MIL-A-63242A(AR)
AMENDMENT 3
14 November 1988
SUPERSEDING
AMENDMENT 2
14 February 1985

MILITARY SPECIFICATION

AMPLIFIER, OPERATIONAL
TRIPLE PROGRAMMABLE MICROPOWER

FIGURE 1 - Terminal Assignment and Logic Diagram

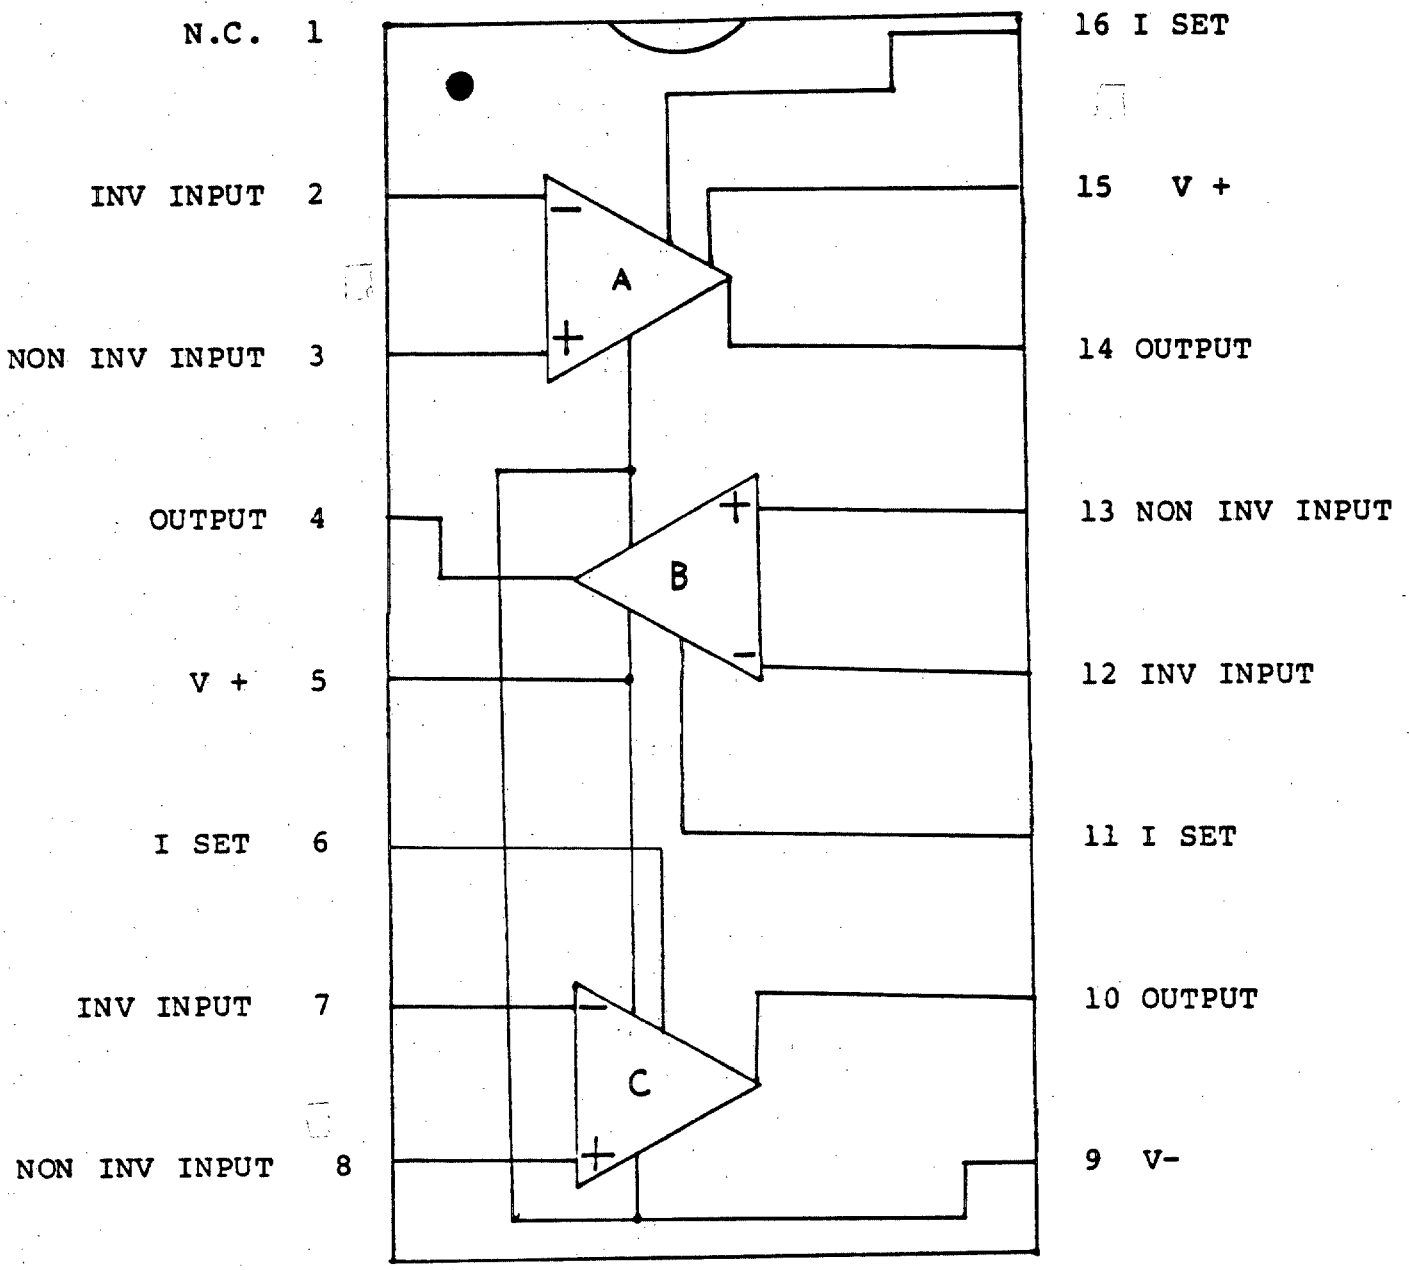
Delete Figure 1 and substitute new Figure 1 included.
